Value Engineering Study

Dining Facility Prototypes

Prepared for
Norfolk District
US Army
Corps of Engineers

Subject: Value Engineering Report, Dining Facility Prototypes

INTERIOR VIEW OF FLAT ROOF CLERESTORY APPLICATION

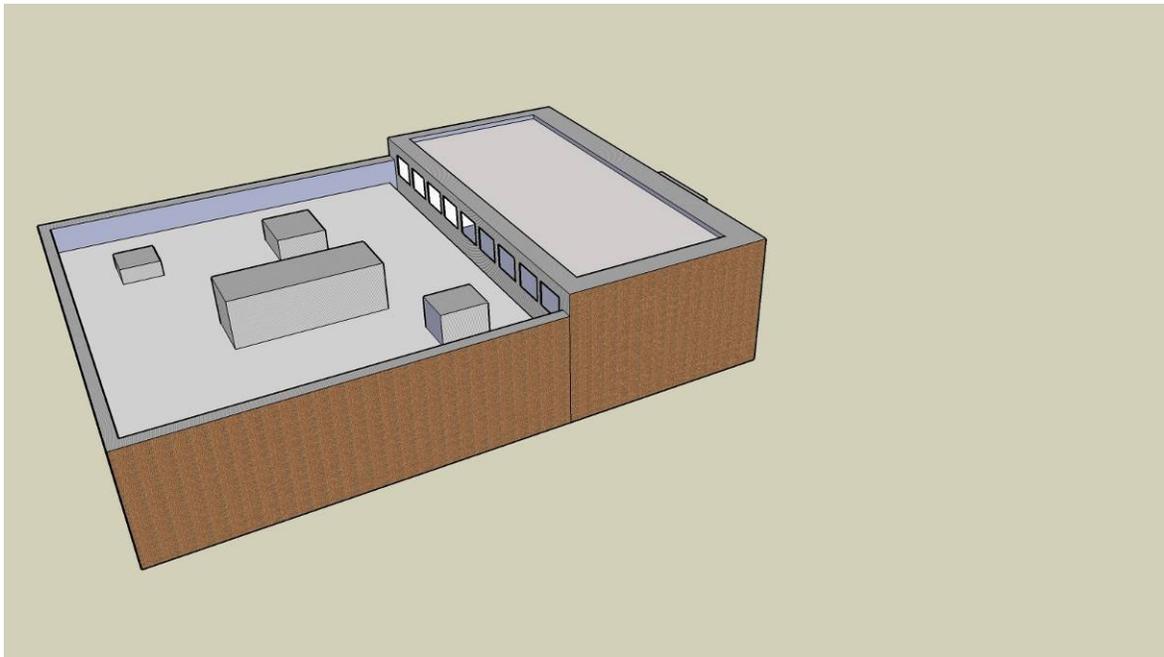
The current scheme for the permanent party facilities presents a Clerestory projecting approximately 8 ft. from the roof structure. The proposed roof plan is complex using integrated roof clerestories of 2 types.

Simplify the approach to incorporating interior building natural light and shielding equipment with a simple parapet. Accomplish these design parameters with a simple forms approach, as shown in the attached drawings. The VE Team proposes using prefabricated skylight type covers with a low rise curb for support

CURRENT SCHEME

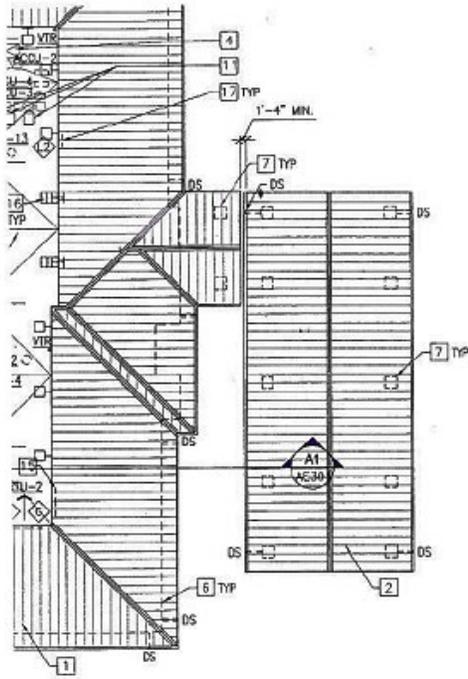
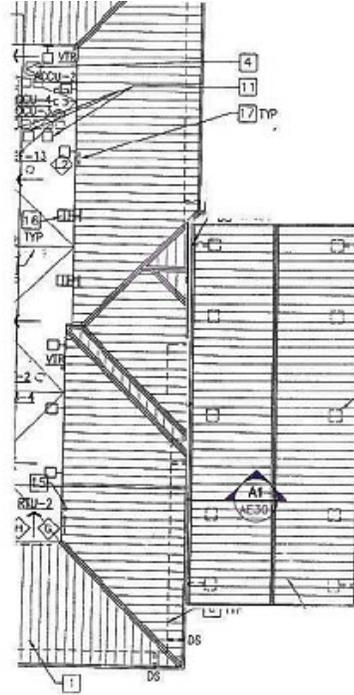
The current scheme presents on each side of the Trainee Dining facilities main canopies completely isolated from the building structure and a separate small canopy for the entrance to the vestibule. There is a gap (approximately 1'-8") between the main canopy and the small canopy which will allow exposure to rain water. For the 2600 Soldier (two story) structure there are two main canopies next to each other with a small gap between them (approximately 1'-4") that will also allow exposure to rain water.

In order to eliminate exposure to rain water and reduce coverage area, the proposed scheme combines all the canopies into one and brings them next to the building.

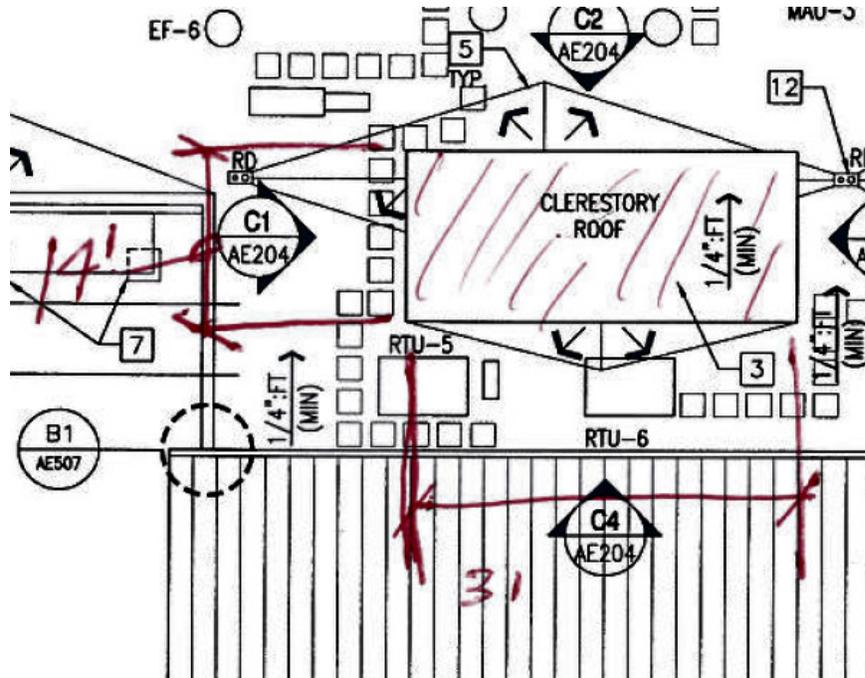
Drawings show a raised rectangular light well with glass in the vertical portion.

Replace the light transmitting structure with commercial skylights about 8 feet square. Commercial skylights are pre-engineered and warranted by the manufacturer. Many glass coatings and shadings are available.

This proposal is applicable to the 500 and 800 soldier facility. The marked-up drawing above includes a detail from Drawings AE106 and AE204, respectively.

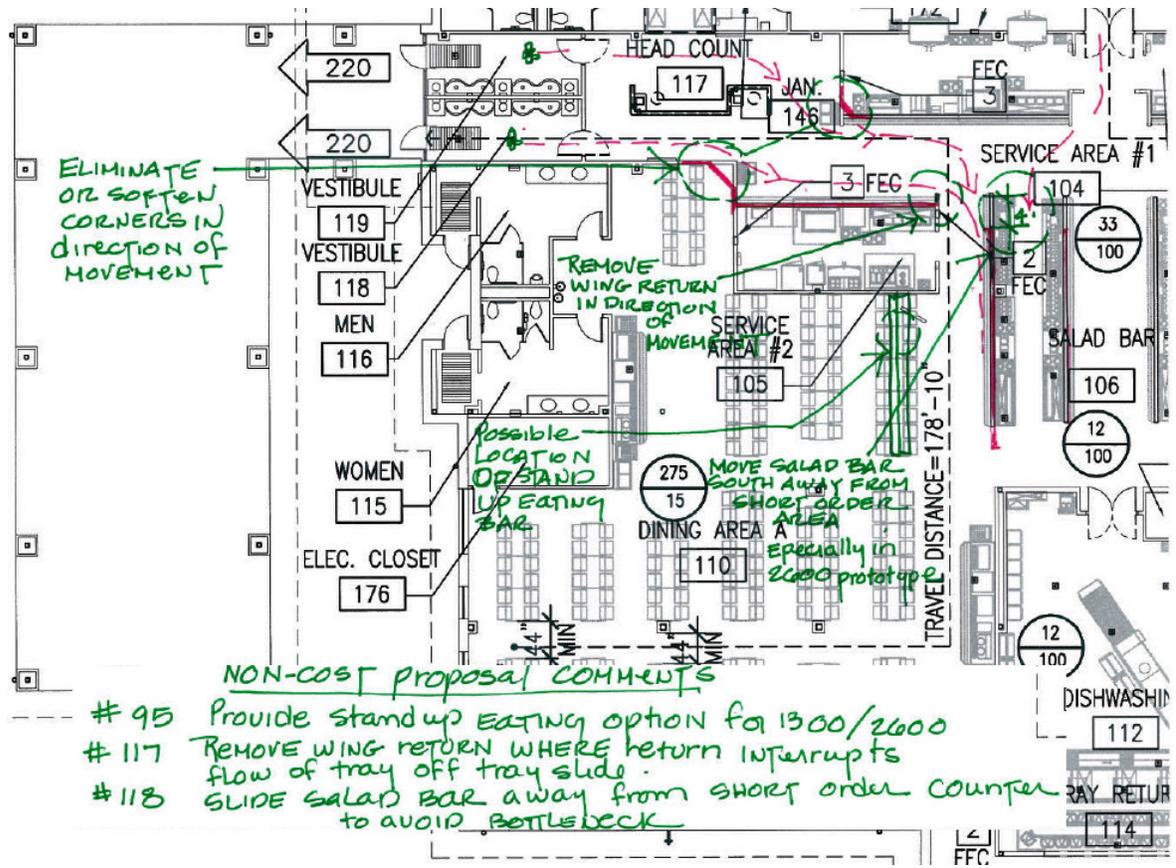
Design team has indicated that soldiers are moving in two different lines. Circulation shown in not fluid and these comments are meant only to possibly redefine the circulation corridor shape.

- Provide stand-up eating option for 1300/2600 AIT facilities.
- Remove the wing return where the return interrupts the flow of trays off the tray slide.
- Slide the salad bar away from the short order counter to avoid creating a bottleneck.

The first idea was to provide an alternative for eating quick meals. During the outbrief, however, it was noted that personnel in the AIT facilities march in, get their food, and all sit and eat as a uniform group. The idea may actually be more applicable to the 500/800 person facilities since customers there would be more appreciative of alternatives.

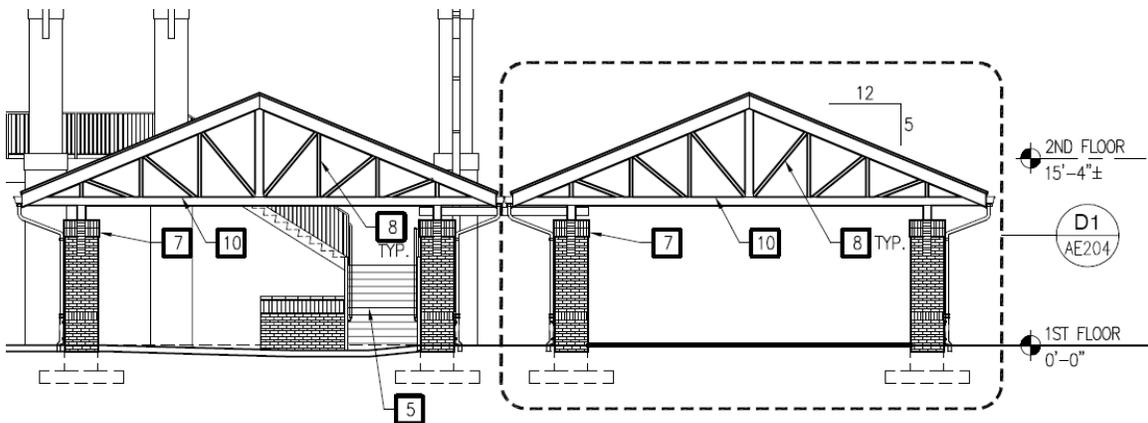
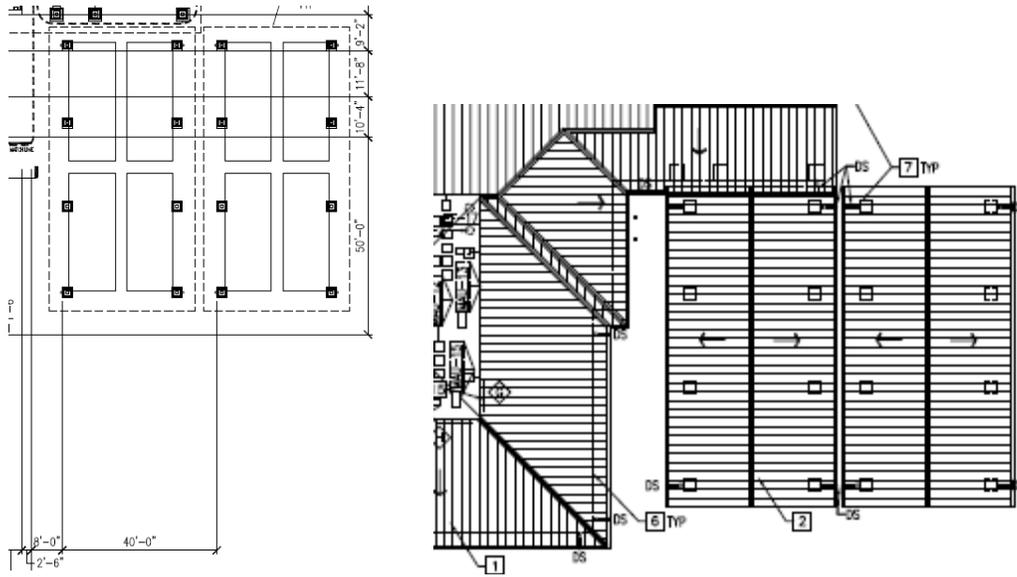
Outside the two-story 2600 AIT dining facility, two queuing areas are shown side-by-side with separate structures, including columns, roofs, gutters and downspouts.

The following roof plan shows how the two structures convey storm water toward the narrow divide between them. Any rain falling between the two gutters would land on the shared slab.

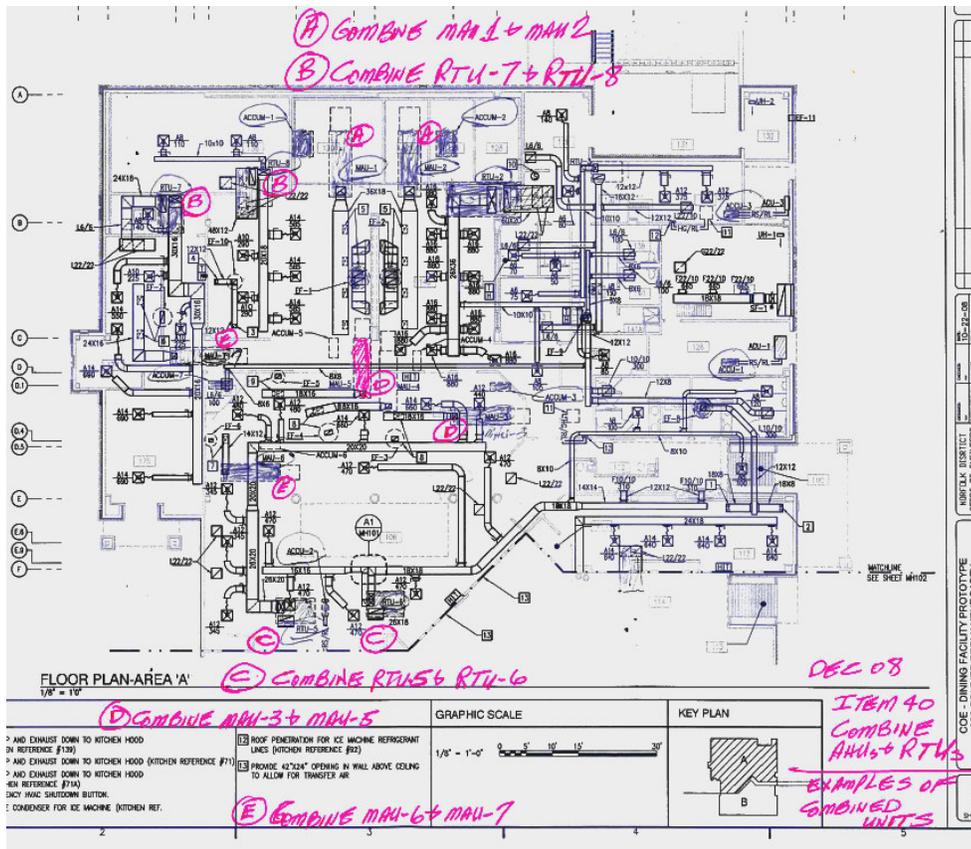
Drawing M-602 now showing 7 MAUs and 8 RTUs on the roof.

Reduce the number of MAUs and RTUs. Combine MAUs to four units. Combine the RTUs to four units. Units to be combined are shown below in the markup of Drawing MH101 for the 800 soldier facility.

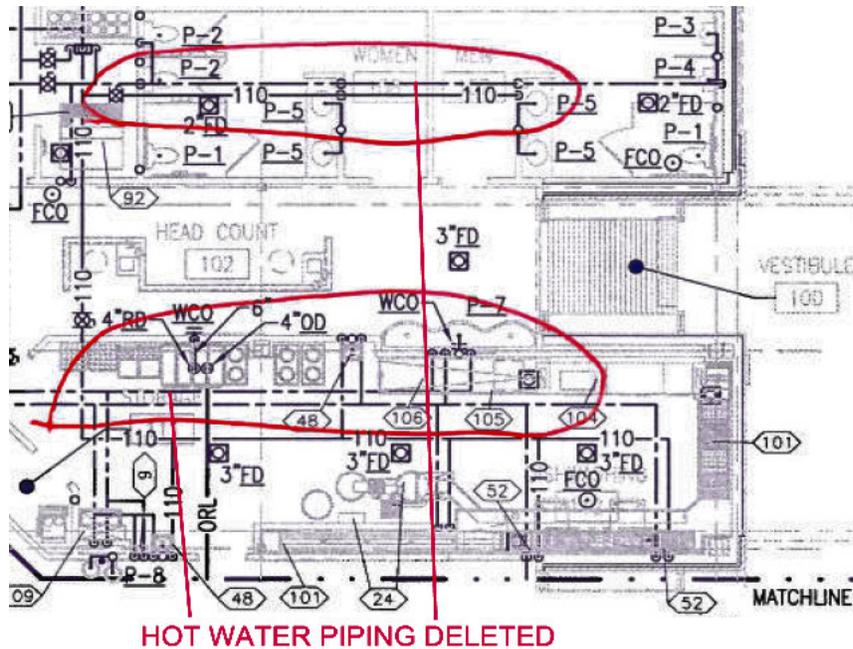
Drawing PL103 shows 110 F hot water piped to the lavatories in the restrooms and for the hand wash at the entry. This is for the 800 soldier dining facility. The other units are similar.

Use Instantaneous Electric HW units for the lavatories in the restrooms. Use Instantaneous Electric Water Heaters for entry hand wash. This will eliminate piping and reduce the amount of hot water to be stored.

A-1 Relocate Room # 134 (FIELD FEED)

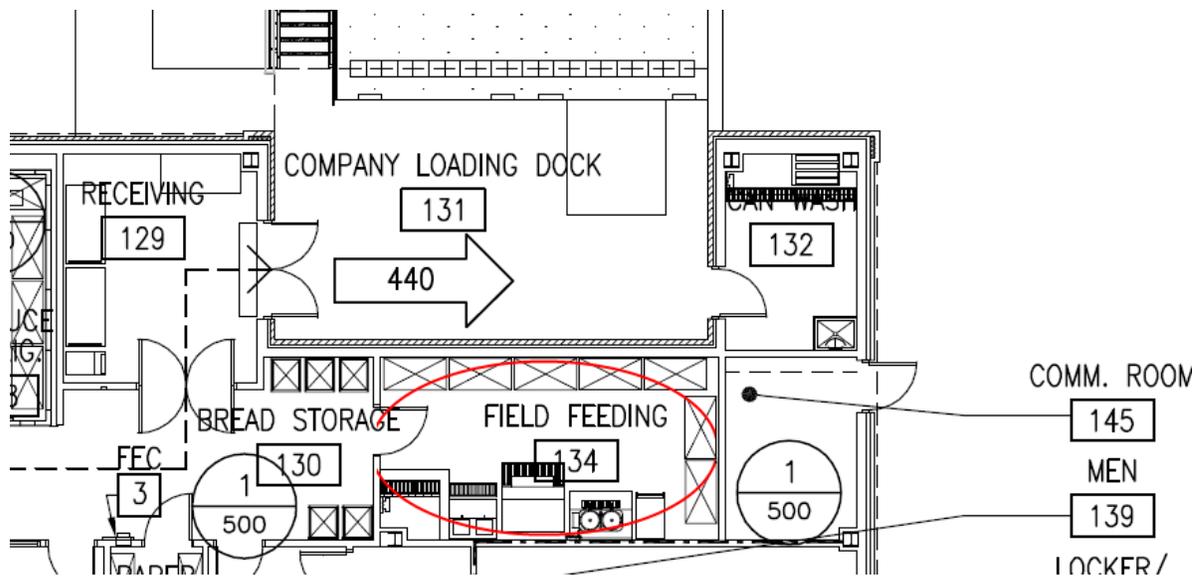
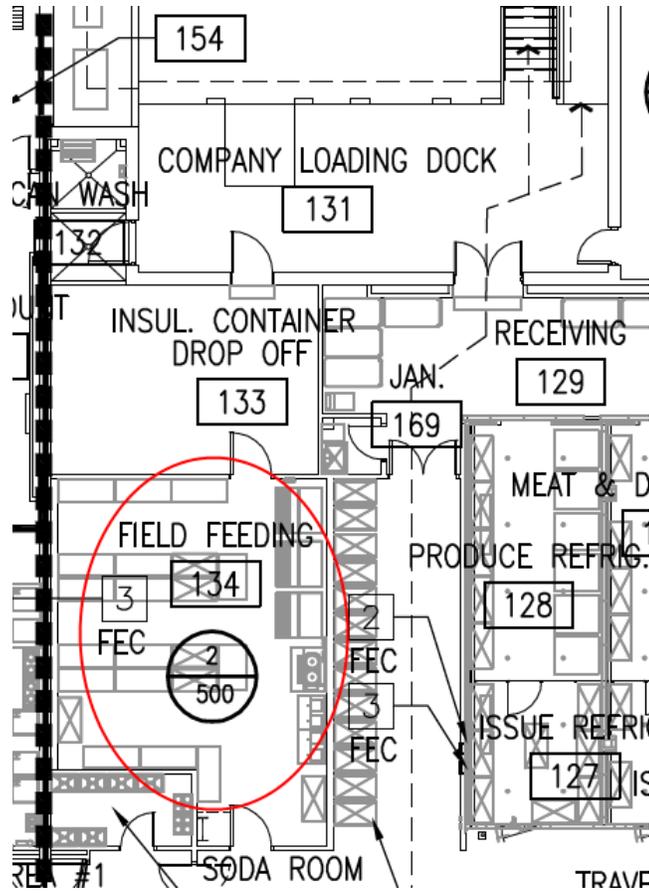
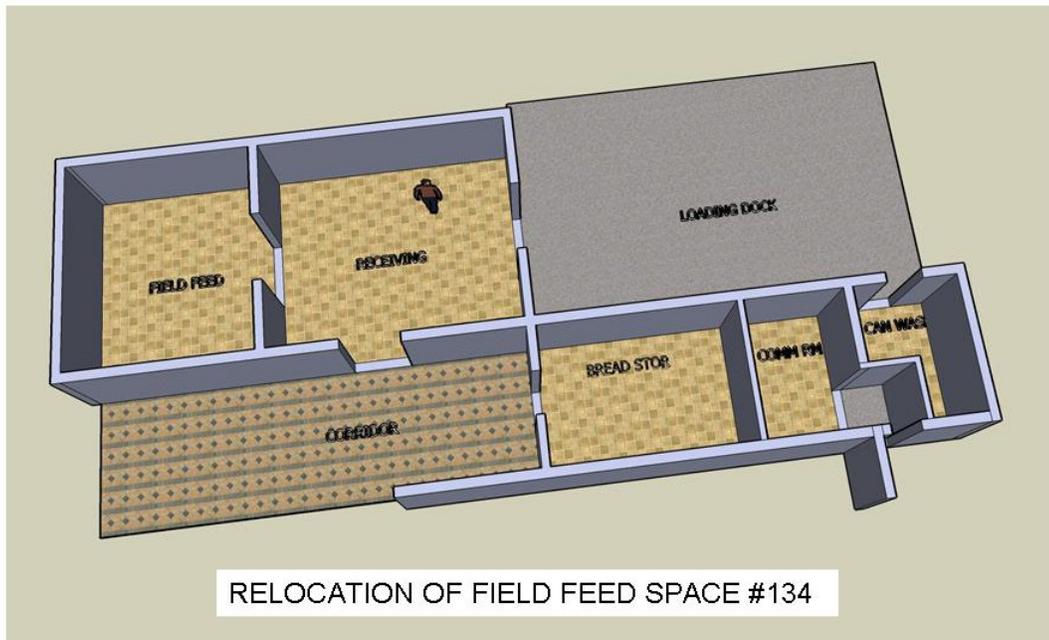
The circulation flow from the Loading Dock Space #131 is critical for the receiving of food supplies. The major circulation of goods will be coming into the facility. However, the Field Feeding space # 134 will be a staging space for prepared foods leaving the facility via the Loading Dock. In order to streamline circulation in Receiving Room 129, it is suggested that the Field Feed space be moved adjacent to Space 128 “Produce Refrigeration”. The Loading dock would move to the east and the Can Wash Room 132 and Command Room 145 would move down into the space vacated by the Field Feed. Figure 1 shows current arrangement for 800 PP facility; 500 PP facility is identical. Figure 2 shows current arrangement for 2600 AIT facility. See Figure 3 below for proposed solution for 500 PP and 800 PP facilities.

A-2 Provide Access to Restrooms in Prototype 500 and 800 Dining Facilities

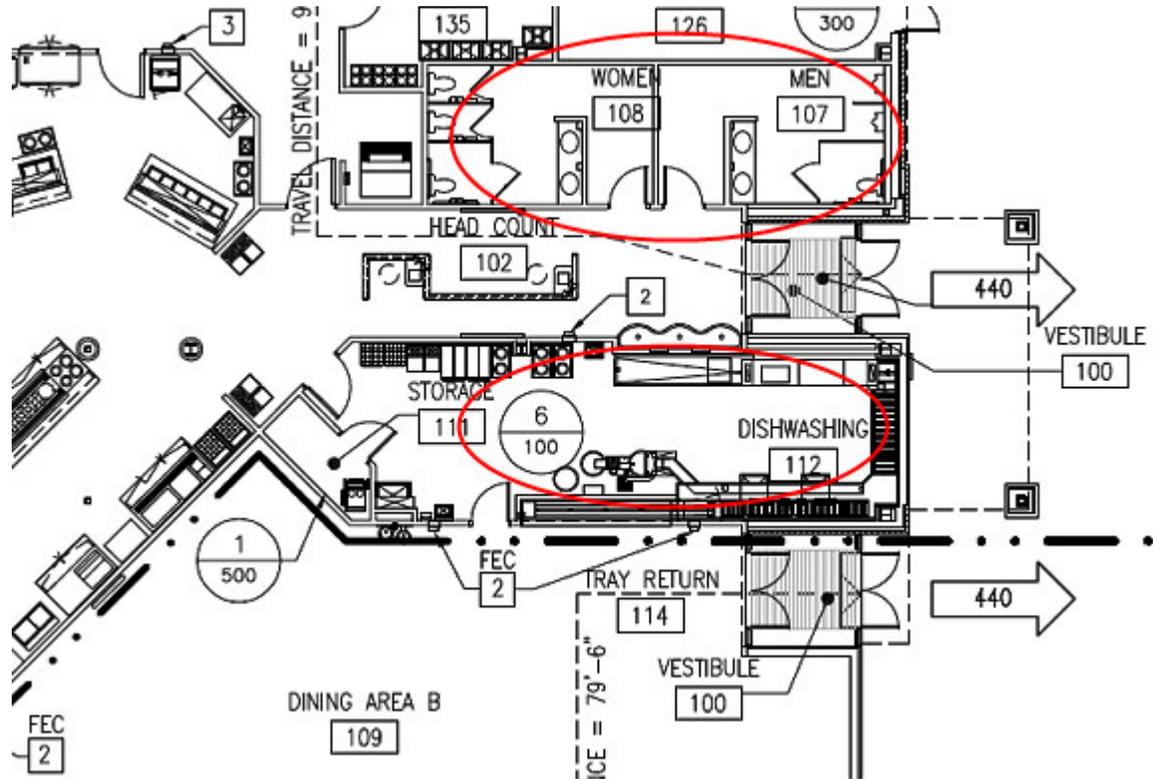
Consideration should be given to relocating the Dishwashing Space #112 in such a way that access to the Restrooms can be provided from the sitting area. As shown in the drawing below, a diner would have to travel through the servery in order to reach the entrance of the restrooms which is west of the entry doors in Vestibule Space #100. If a small corridor or door could be located between the Dining Areas and the Vestibules, a diner could also use the restrooms after he has eaten.

A-12 Eliminate gaps between serving stations

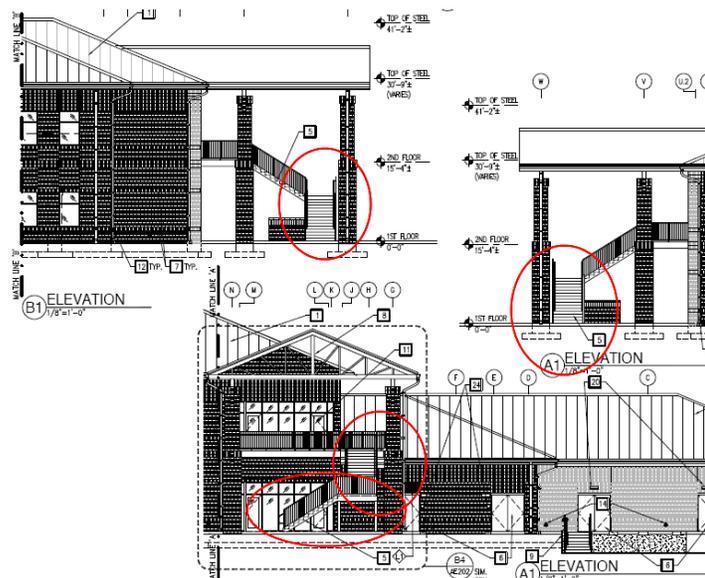
In the facilities of lower occupancy where the servery stations are disconnected, suggestion is made that lift-up gates incorporating tray rail or similar barriers be designed so that diners crowding each station do not stand in the openings between stations while waiting to place orders or receive orders. Diners infringing into back of the Servery areas can disrupt normal operation of the facility.

A-15 Add soffit or screening to prevent bird roosting under canopy

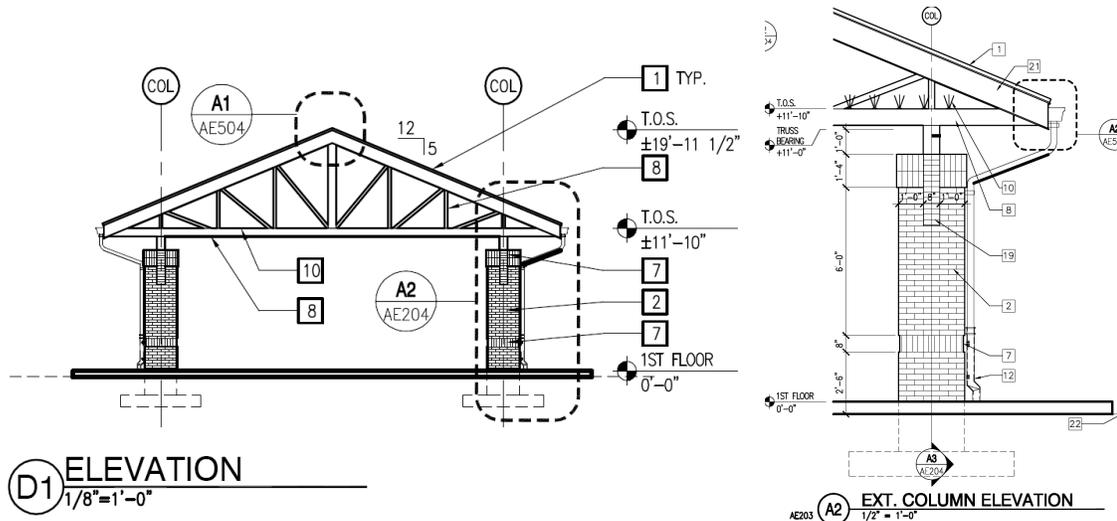
While the details of the framing for the canopy indicates placement of 7" ledge stainless steel bird spikes, diagonal members still present opportunities for bird roosting, which would be a nuisance to soldiers waiting for meals. It is suggested to use soffits, screening or an alternative non-truss frame to eliminate this.
